State, Federal and Tribal Fishery Agencies Joint Technical Staff

February 26, 2003

We thank you for the opportunity to provide comment on the Independent Scientific Advisory Board's (ISAB) draft document "Review of Flow Augmentation: Update and Clarification" as it relates to the Northwest Power Planning Council's Draft Mainstem Amendments. The document provides several conclusions with which we agree:

Figure 1. Hypothetical response of survival to composite uncontrolled factors and flow.

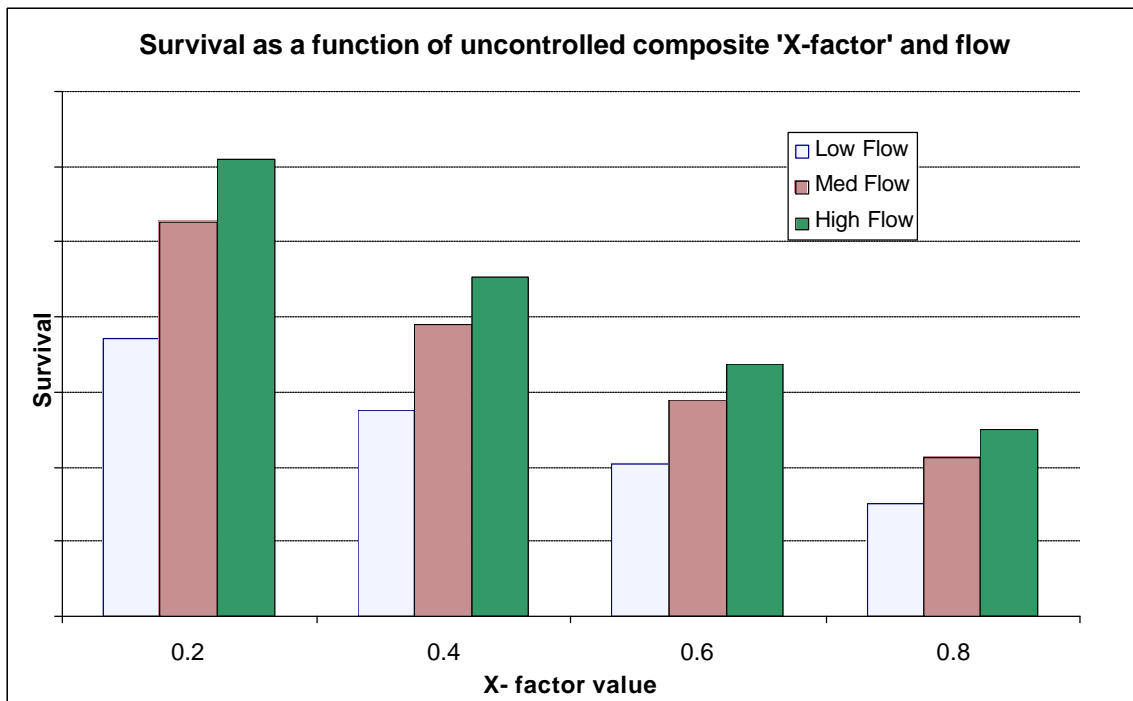
A plot of survival rate under different flows and different uncontrolled factors may help illustrate the difficulties in detecting a true relationship between flow and survival, given that uncontrolled factors also are certain to affect survival rate. Uncontrolled (and unmeasured) factors might be intrinsic, such as smolt physiological condition, or they could be largely external (e.g. predator density-dependent functional response). If we consider a component of survival (or mortality) that is influenced by uncontrolled factors, and one that is influenced by flow, the flow-survival relationship could be obscured by either random or directional variation in uncontrolled survival factors. Variation within a season will tend to obscure an intra-annual flow-survival relationship, and variation between years will tend to obscure an inter-annual flow-survival relationship. In Figure 1, a hypothetical composite factor, which can take values from 0 to 1, is shown on the x-axis, with resulting survival rate shown for low, medium, and high flows. The x-factor survival component varies as a negative exponential function of x-factor value, while flow-induced survival varies as a positive exponential function of flow. We can see from the figure that even though there is positive flow-survival relationship (i.e. at a given uncontrolled factor level, higher flows always result in higher survival), it could be lost in the data if the uncontrolled factors vary within a season or between years. For example, a year with higher flow may have also have a higher x-factor, resulting in lower overall survival than a year with lower flow but lower x-factor.

Figure 2.

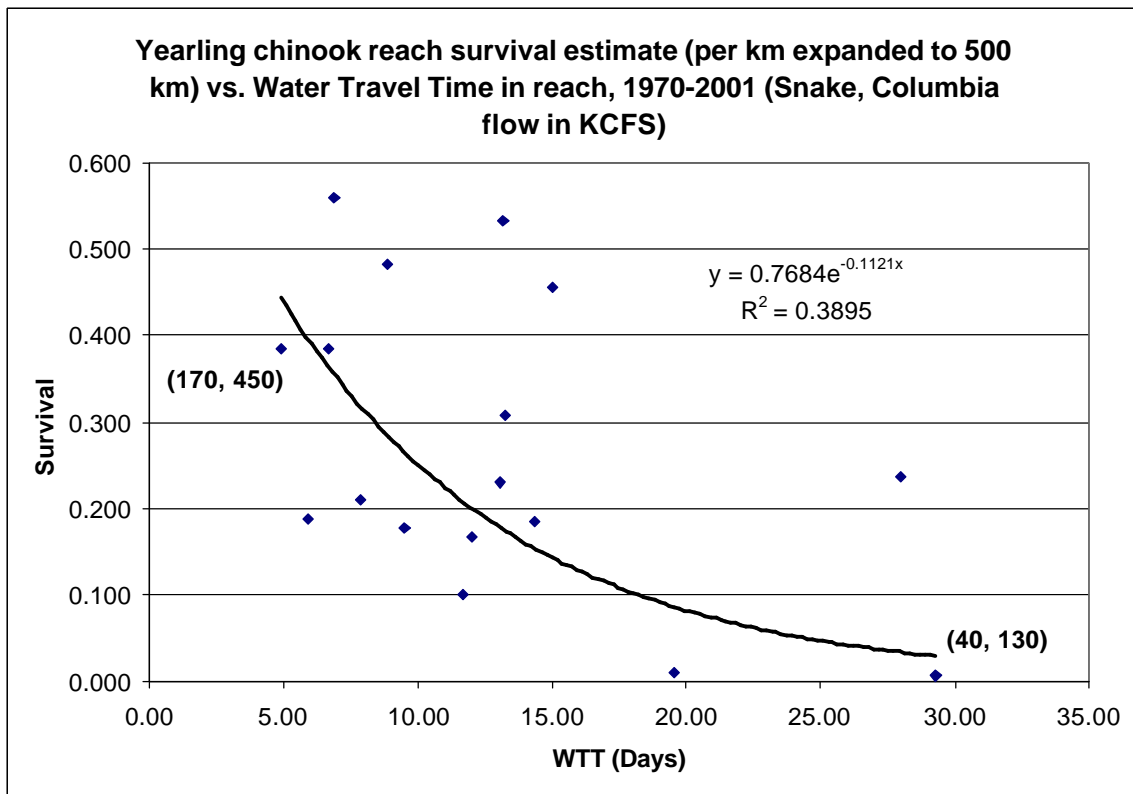
Figure 2 shows data for yearling chinook, from the full time series. With data from the 1970s included, there is a significant survival /WTT relationship.

Figure 3.

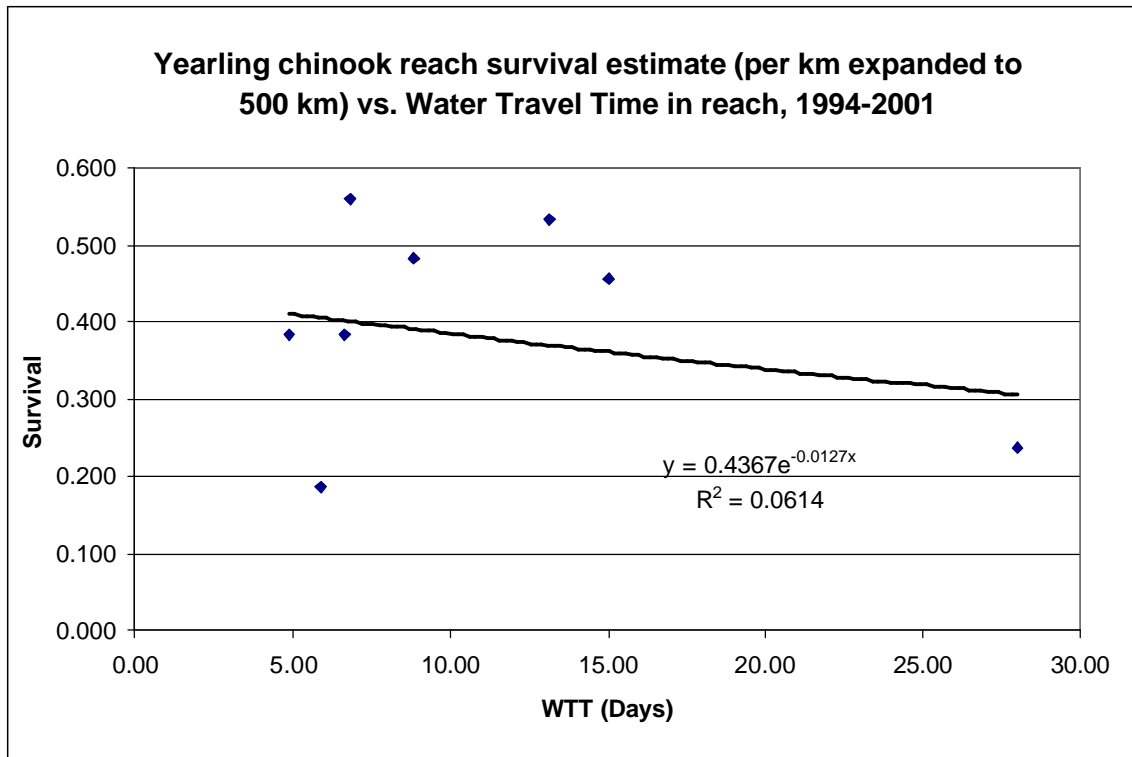
The inclusion of data from 1970-80 is controversial, as some believe unique conditions in some of those years resulted in some low flow/low survival years that would not occur again. For yearling chinook, with the recent, PIT-tag data only, no survival/WTT relationship is apparent (Figure 3).

Figure 4.

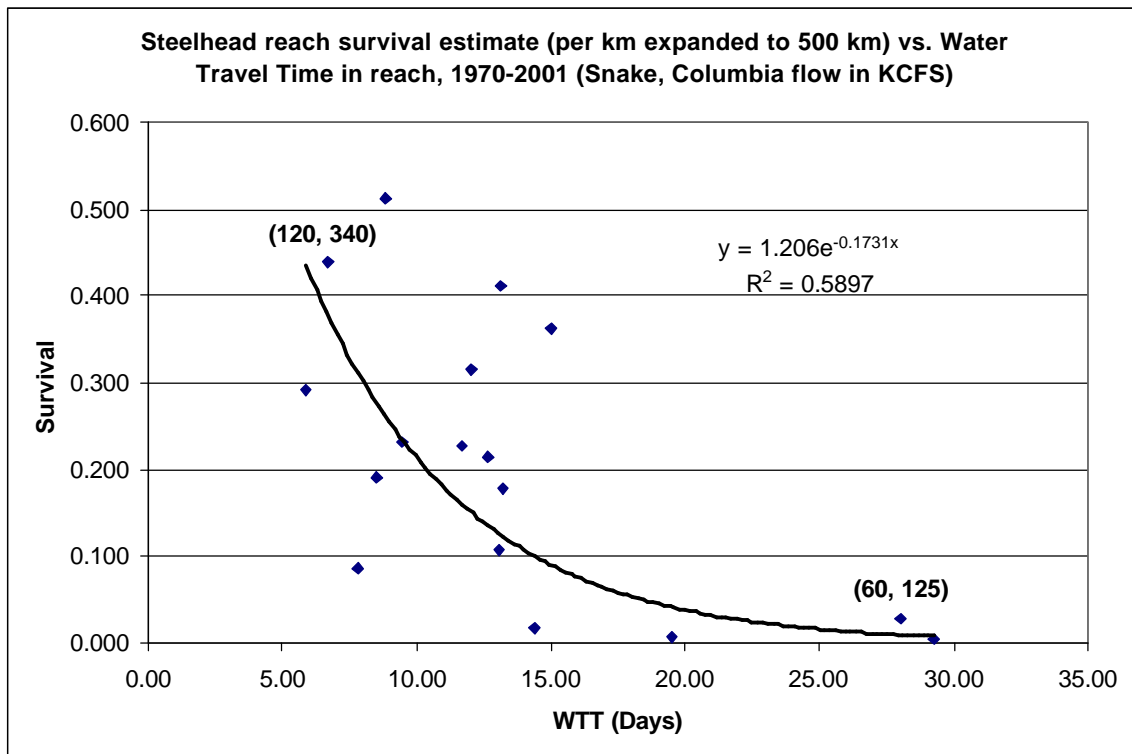
Figure 4 shows the results for migrating steelhead with the full time series. A strong survival-WTT relationship is indicated.

Figure 5.

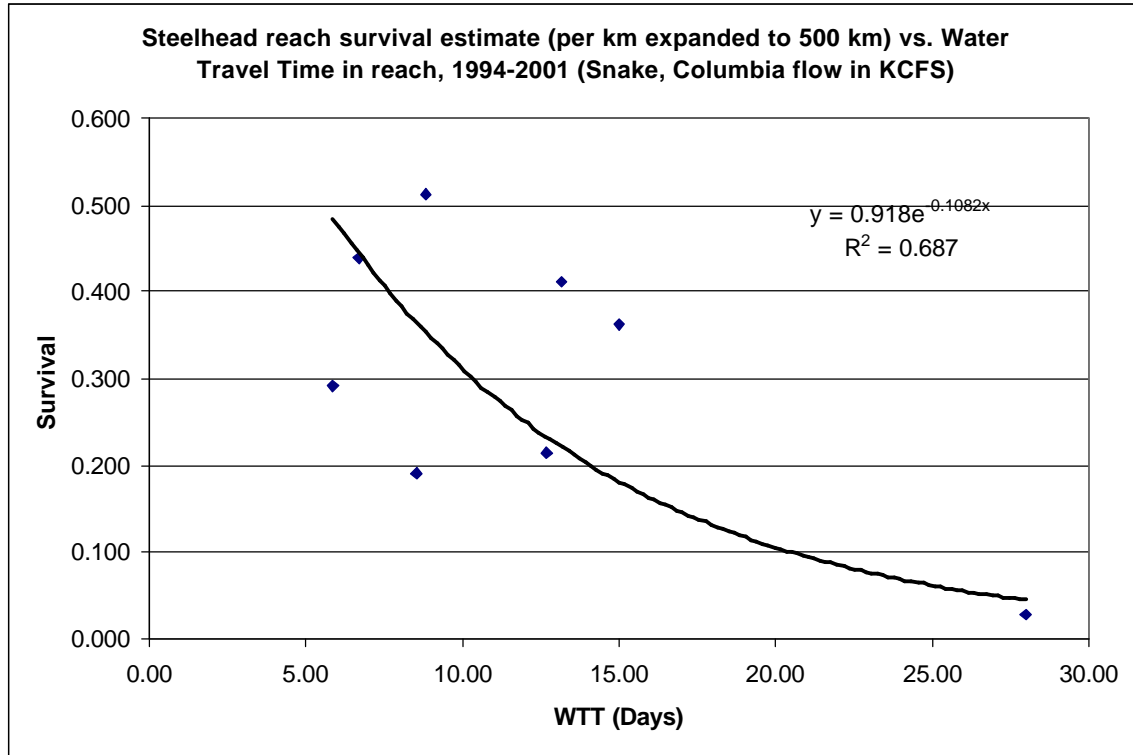
When we exclude the older data, and use only the PIT-tag data, the survival-WTT relationship for steelhead seems even stronger (Figure 5).

Figure 6.

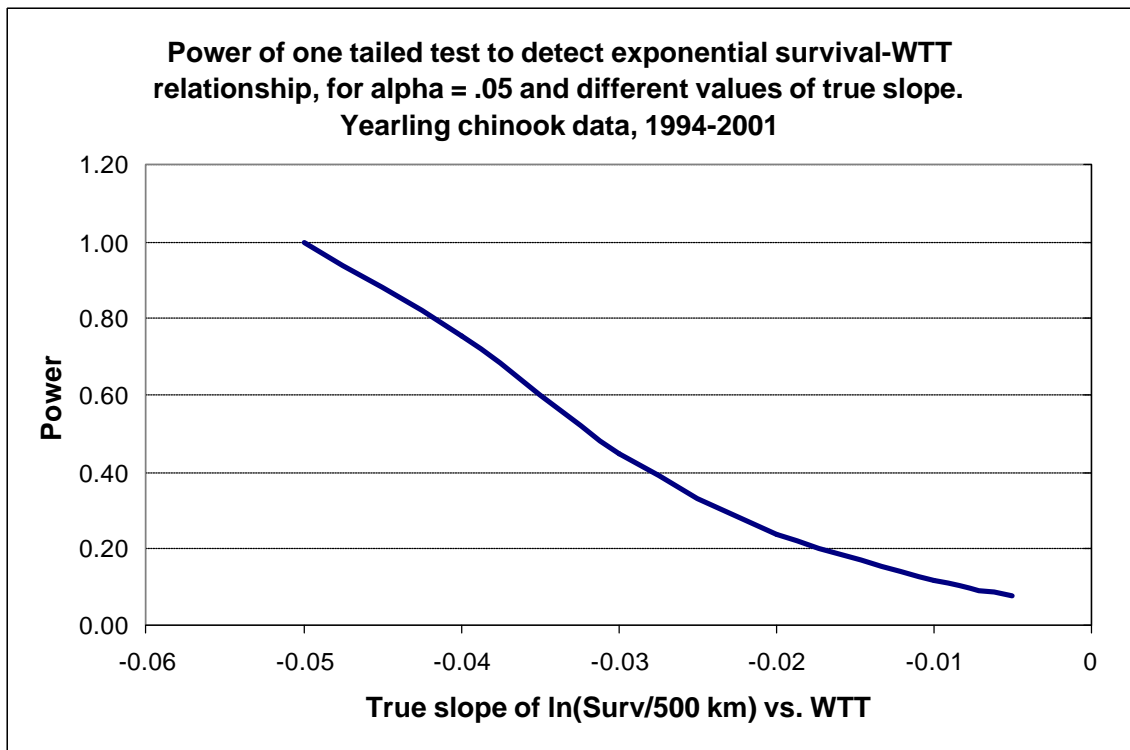
A formal power analysis can be done for the data presented. Because no relationship was found for chinook using PIT-tag data only (Fig. 3), we perform an analysis of power to detect an exponential survival-WTT relationship on this data set. We assume a one-tailed hypothesis test on the slope of natural log of survival vs. WTT; i.e. the null hypothesis is that $b \geq 0$; and the alternative hypothesis is $b < 0$ (representing a positive relationship between flow and survival). The observed standard deviations of the X and Y values are used, with different levels of "true" underlying values of b . Power for the regression is estimated as in Zar (1984, section 19.4) using the correlation coefficient r (which is directly proportional to b if the ratio of standard deviations of X and Y is held constant). An alpha value (Type I error rate) of .05 is used. The results are shown in Figure 6 for the 8 years of PIT-tag data.

A commonly accepted target value of statistical power to reject the null hypothesis at $\alpha = .05$ is 80%. Figure 6 shows that this much power would not be expected unless the absolute value of the slope were greater than .04. In other words, there is a substantial chance that a true relationship of as much as -.04 is going undetected in the data. A b value of -.04 represents an additional 4% mortality for every additional day of water travel time.

Figure 7.

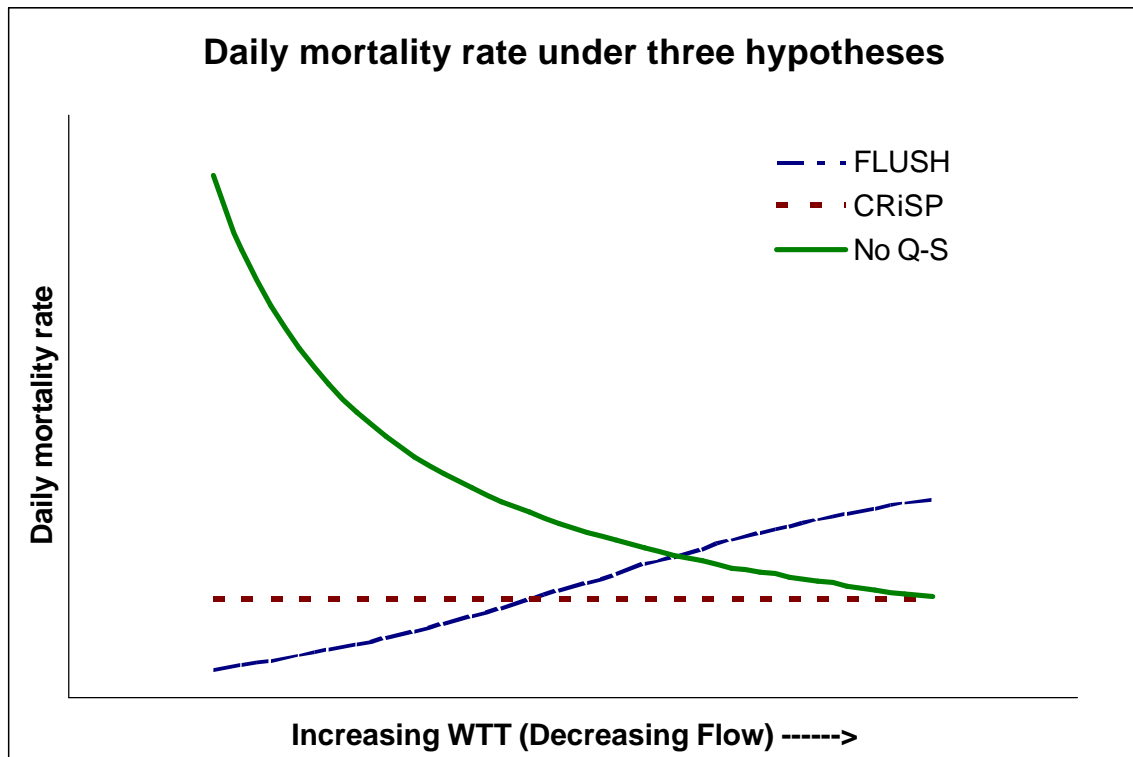
A graph of the form of the relationship between daily mortality rate and WTT (flow) for the three hypotheses is shown in Figure 7. The FLUSH hypothesis, of course, results in a fairly strong survival-WTT relationship, when the increasing daily mortality rate combines with the fish travel time-WTT relationship. The CRiSP constant mortality hypothesis also results in a survival-WTT relationship because of the fish travel time-WTT relationship, though not as strong as in FLUSH. The hypothesis which reflects the assumption of no-flow survival relationship (No Q-S) requires that daily mortality rate increases with flow.

Figure 8.

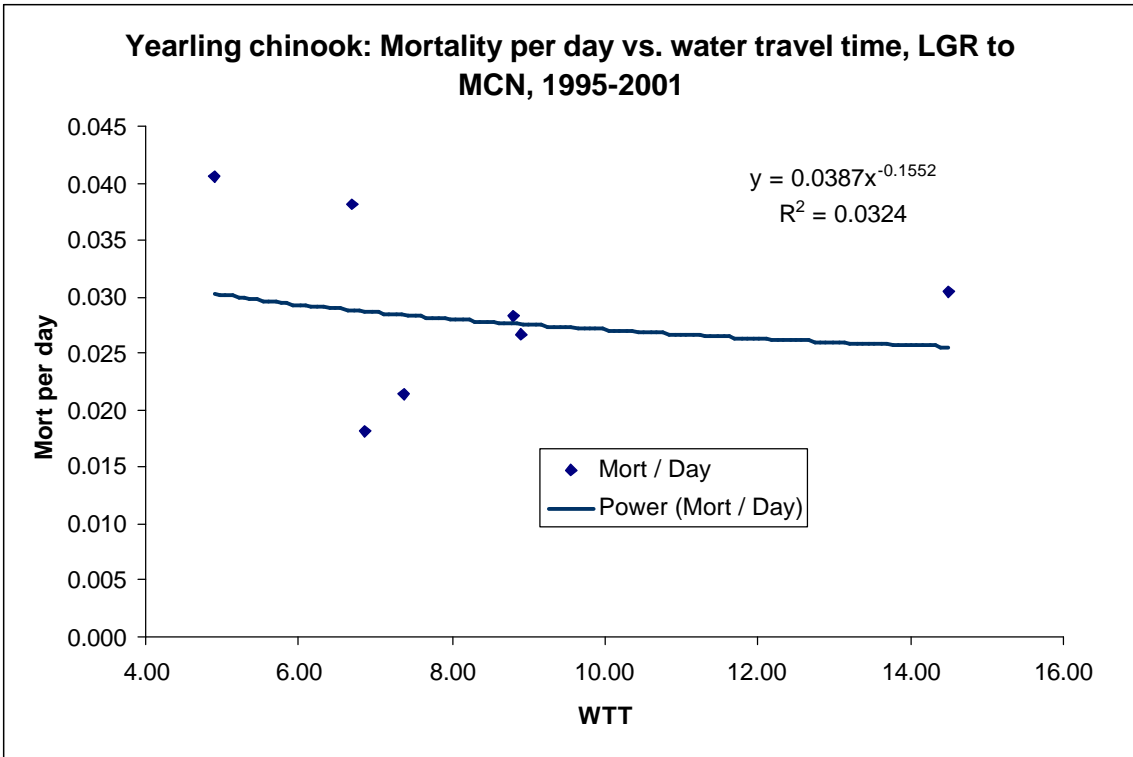
Table 1 shows the data sources for survival rate and travel time estimates. The results of the mortality rate calculations plotted against spring migration water travel time estimates are shown in Figures 8 and 9.

The trend line fitted for chinook in Figure 8 is a power curve. If the no flow-survival hypothesis were correct, we would expect mortality per day as a function of water travel time to tend to follow a power curve with a negative exponent. The low R^2 suggest that the data do not follow this kind of curve, and the no-flow survival relationship hypothesis is not supported. With steelhead (Fig. 9), fitting a power curve gives a positive exponent. An exponentially increasing trend (shown) fit the data even better. The steelhead data also do not support the no flow-survival hypothesis, and in fact show evidence of mortality rate increasing, rather than decreasing, with time.

Figure 1.

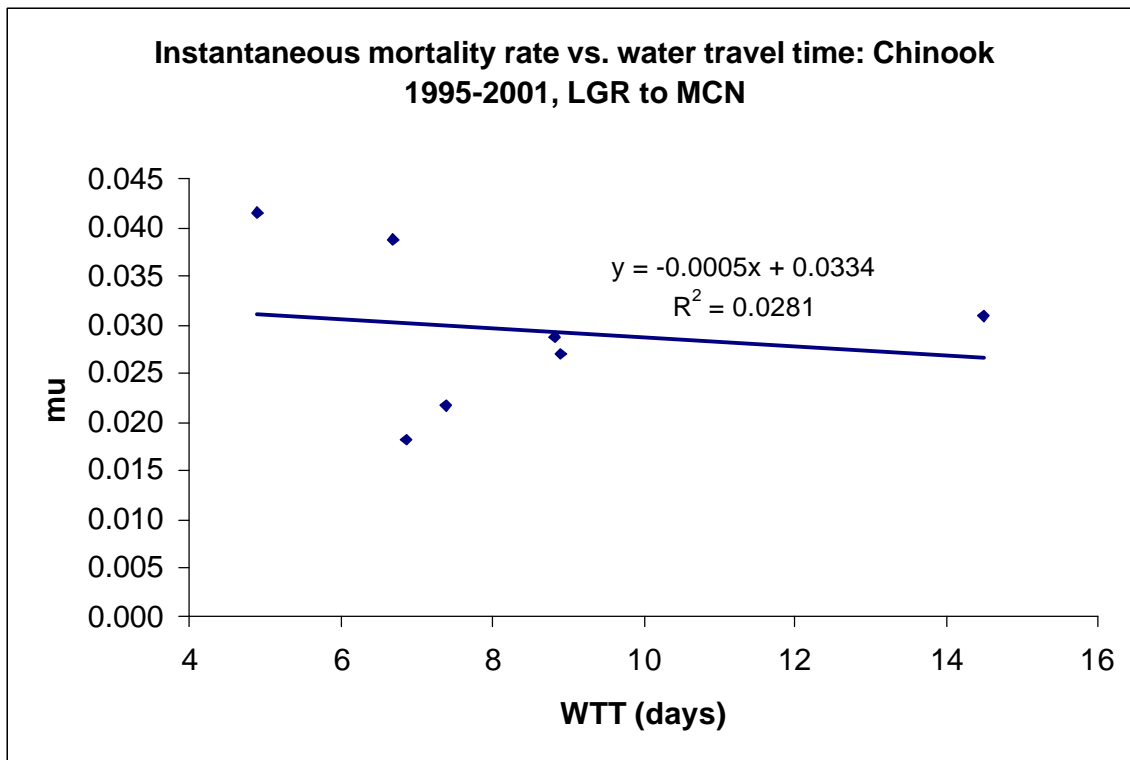
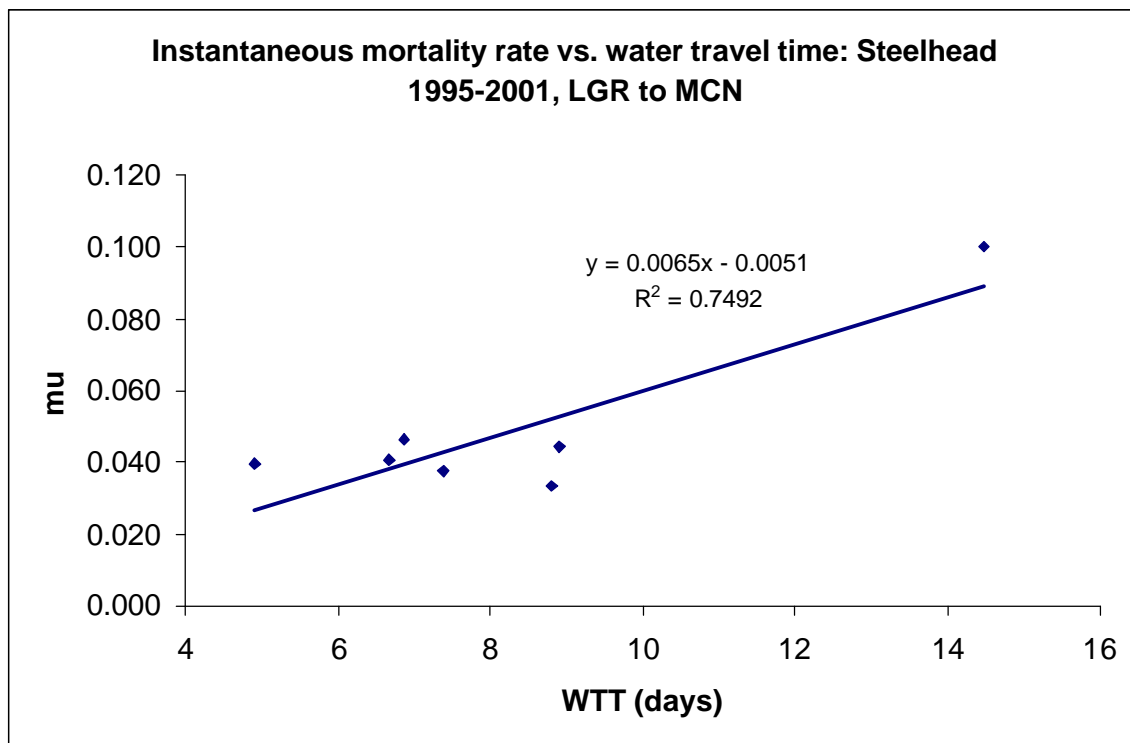
The results are displayed in Figures 1 and 2. Figure 1 shows no relationship between μ and WTT ($p = 0.72$) for yearling chinook; Figure 2 shows an apparent positive relationship between μ and WTT ($p = 0.01$) for steelhead. As expected, these results closely mimic the results for daily mortality rate in Figures 8 and 9 of Appendix A, and suggest the same conclusions: the available evidence provides no reason to reject the null hypothesis of constant mortality rate for chinook, but does provide reason to reject the null hypothesis for steelhead in favor of a mortality rate that increases with water travel time (i.e. increases as flow decreases). In other words, the analysis for chinook supports the ISAB’s contention that the available data are suggestive of the null model, with no relationship between flow and instantaneous mortality rate. The steelhead analysis does not support this contention. In both cases, a positive flow-survival relationship is supported, as fish migration speed through the hydrosystem is strongly and positively related to flow. The alternative hypothesis of no flow survival relationship would require instantaneous mortality rates to increase as flows increased, contrary to this empirical evidence on survival and fish travel time.

Transport Proportion Vs Delta

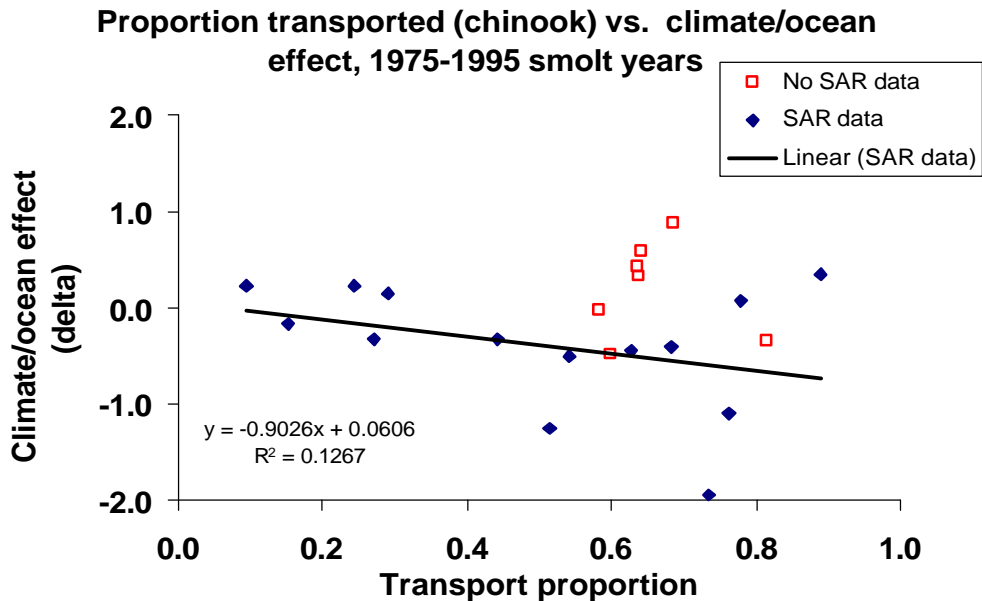
ISAB Question XIII

Any relationship between proportion transported and delta appears to be weak

It is apparent from the data that the years with high transport proportions are not always the years with bad ocean conditions
